BRAUM'S ADDITION

SITE PLAN TO SERVE
BRAUM'S ICE CREAM STORE
 ROCKWALL, TEXAS

I have had an opportunity to review the draft site plan for the Braum's location at Yellowjacket and SH-205 and there are some areas that need to be addressed. My comments are as follows:

Agenda Item: P&Z 91-20/SP/FP/CUP - Hold Public Hearing and Consider Recommending Approval of a Request from Braum's for a Conditional Use Permit for a Structure with Less than 90% Exterior Masonry Facade, a Site Plan and Final Plat on a Tract of land Located on Yellowjacket and SH-205

Agenda Item: Braum's Site Plan and Plat

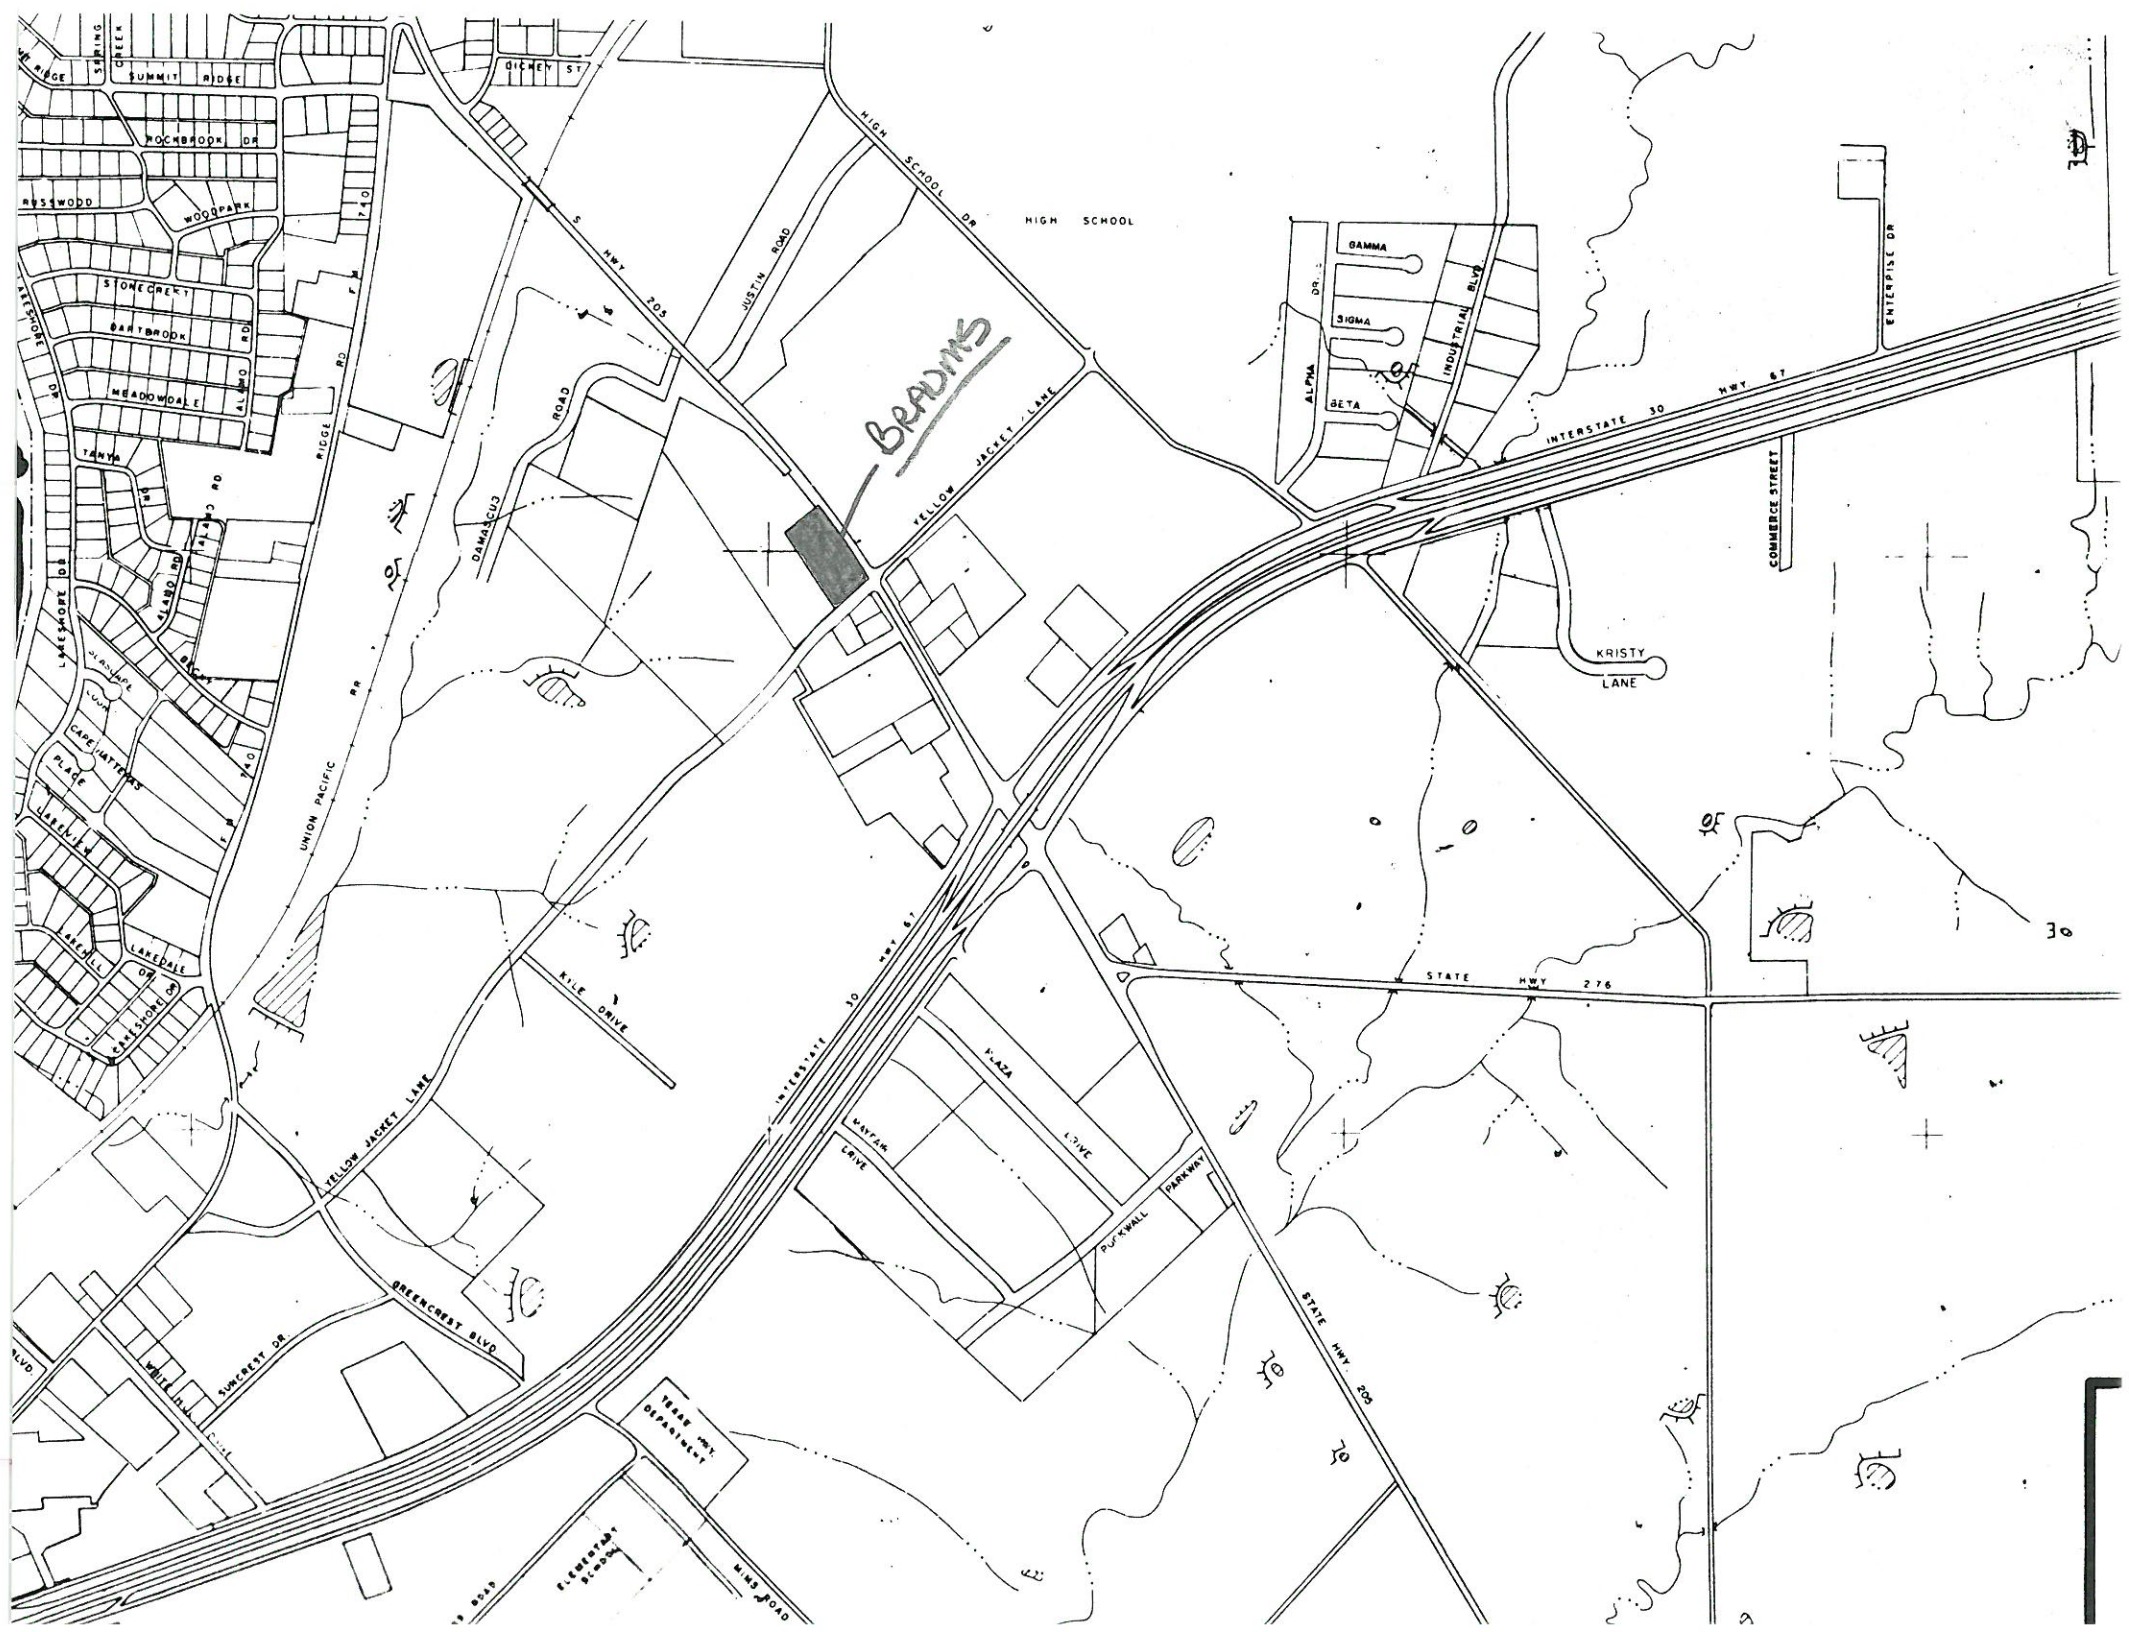
Building Location - The building and the angle parking along the south property line are too close together for two way traffic. This drive would need to be signed as one way.

1. The two entrances onto SH-205 are located approximately 150 feet apart. Our current standards require that drives be located at least 200 feet apart unless a waiver is granted. It was pointed out that when SH-205 is widened there is no median opening planned for this site.
2. It was recommended that the entrance off of Yellowjacket be reduced from 40 feet. As shown the outside radius of this entrance will conflict with the radius of the adjacent driveway into the apartments. Again, there is no median opening planned for this area when the road is widened to a 4 lane divided section.
